Re: S/D 90-48 - (Final Plat) Cedar Meadows Addition

CEDAR MEADOWS ADDITION

STAFF COMMENTS:

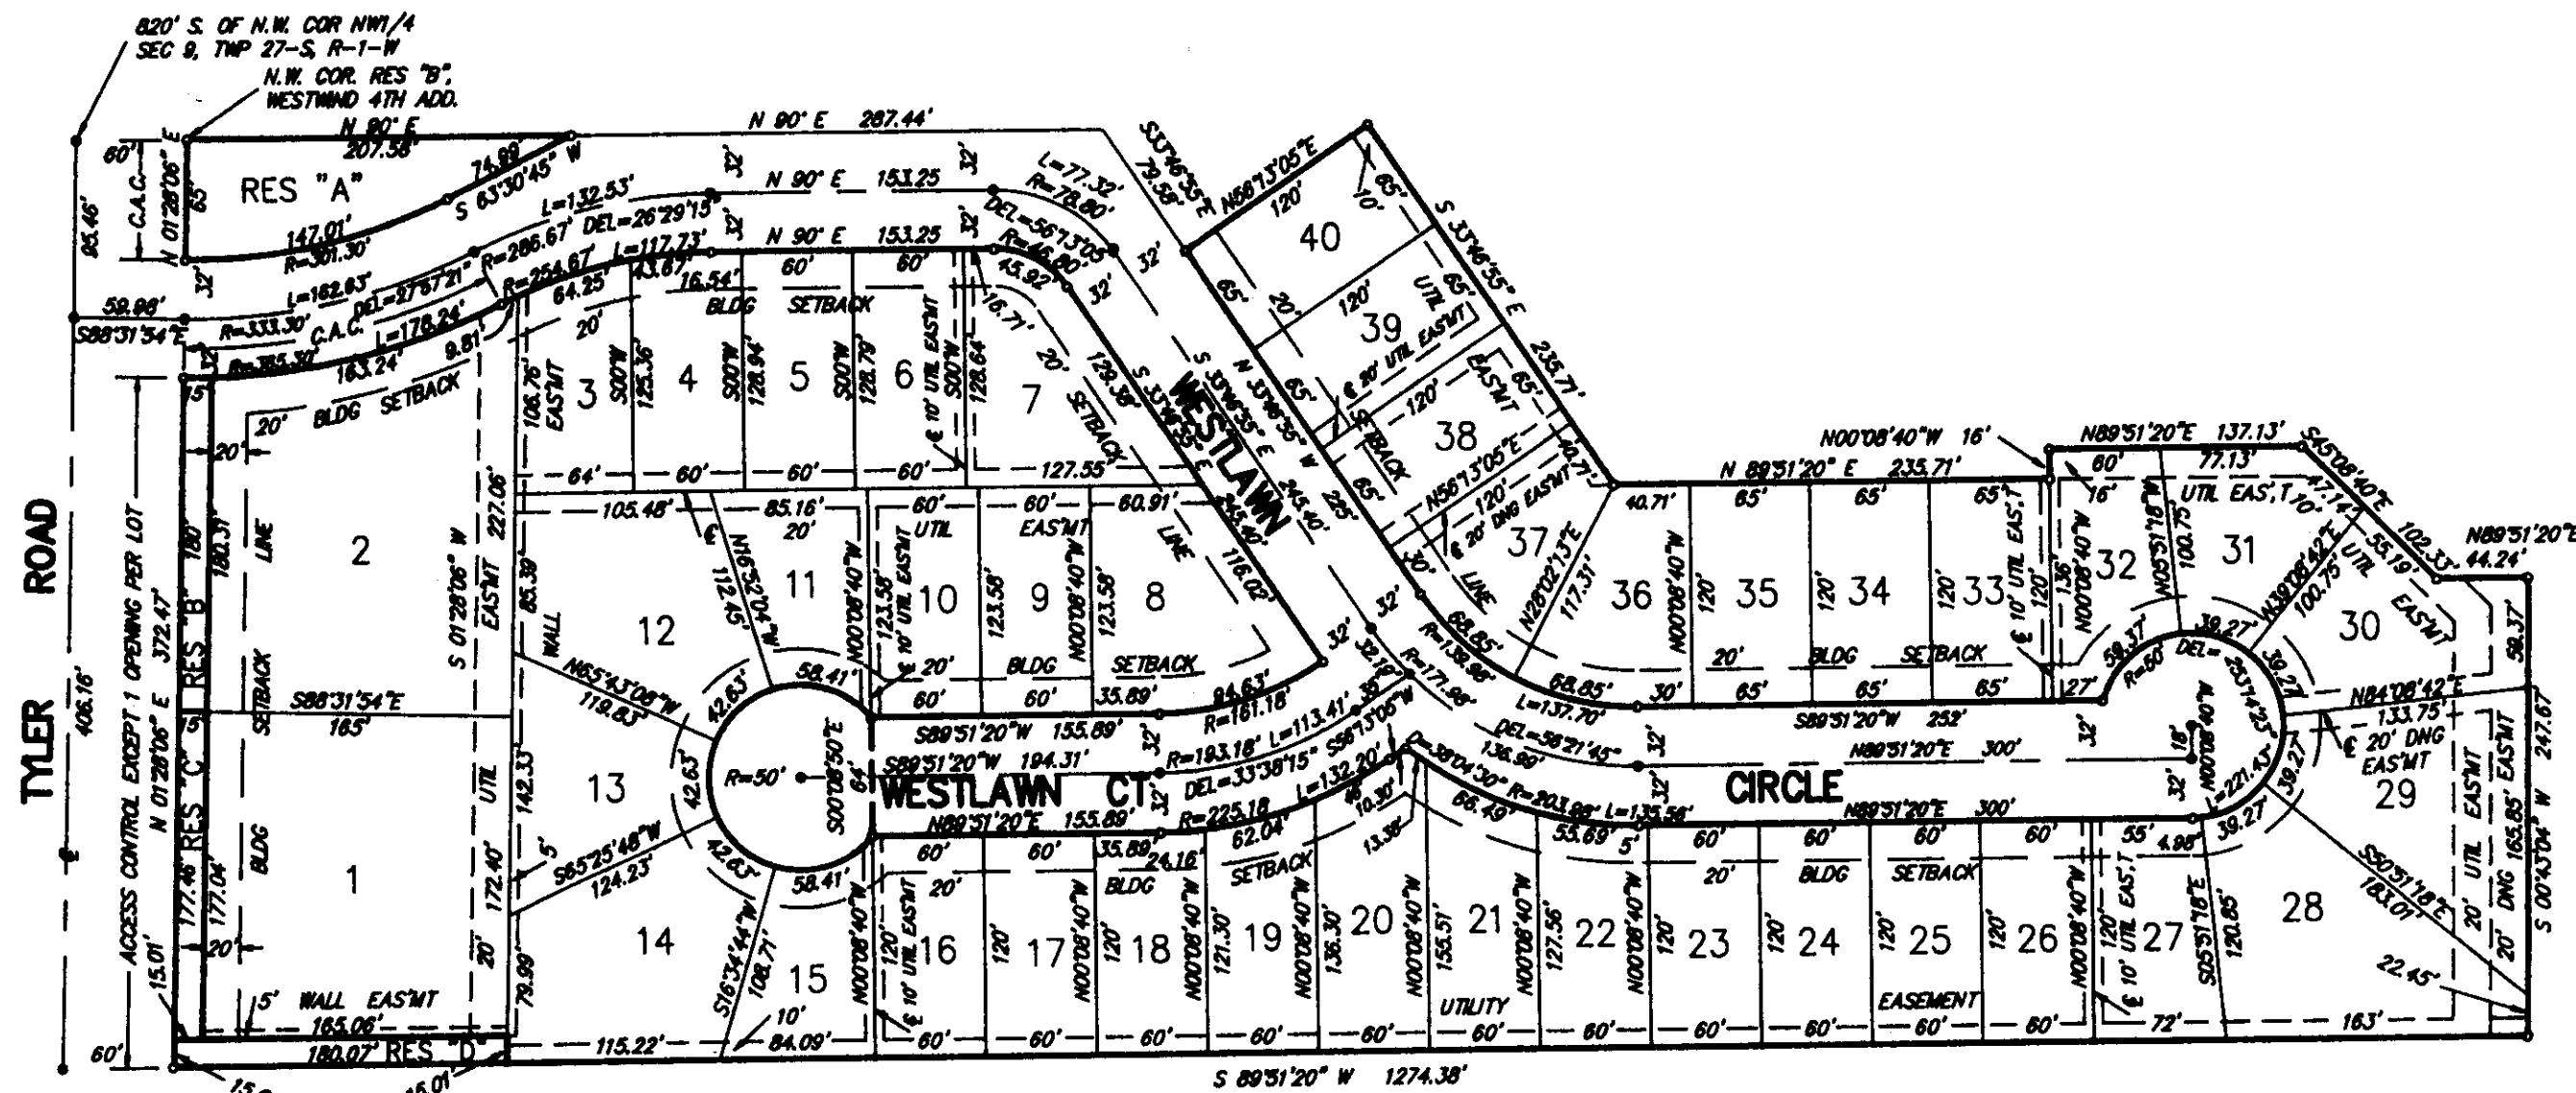
On the final plat, as indicated in the CUP for 64-foot street rights-of-way, 25-foot building setbacks shall be indicated as the front yard setback for all residential lots.

On the face of the plat and in the plat's text, it shall be indicated if the minimum building pad elevations refer to the minimum floor or opening level.

On the final plat tracing, the following revisions shall be made to the plat's text:

~~Line 3 shall be revised to indicate "platted into Lots, Reserves and streets. . ."~~

~~The reference to the Westlawn Court Cul-De-Sac being dedicated, noted in the lower section of the text should accordingly be deleted and replaced with the standard reference of "The streets are hereby dedicated to and for the use of the public."~~

~~On line five, the word reserved has been repeated and needs to be corrected.~~

~~Reserve D shall also be indicated as intended for "the preservation of the existing row of trees."~~

~~In regard to the location of openings being allowed in the areas of access control it shall be indicated that the City Engineer is to approve the location of any such openings.~~

~~I. As requested by KG&E, the final plat tracing shall indicate a 10-foot utility easement along Lot 30 and 38's common lot line and between Reserve B & C's and Lots 1 and 2's common lot lines.~~

~~As indicated by this site's drainage plan, off-site drainage easements shall be provided for this plat. These easements shall be provided to Engineering for approval and to Planning for recording with the plat's approval.~~

~~N. Perimeter closure computations shall be submitted with the final plat tracing. Section 5-101(c).~~
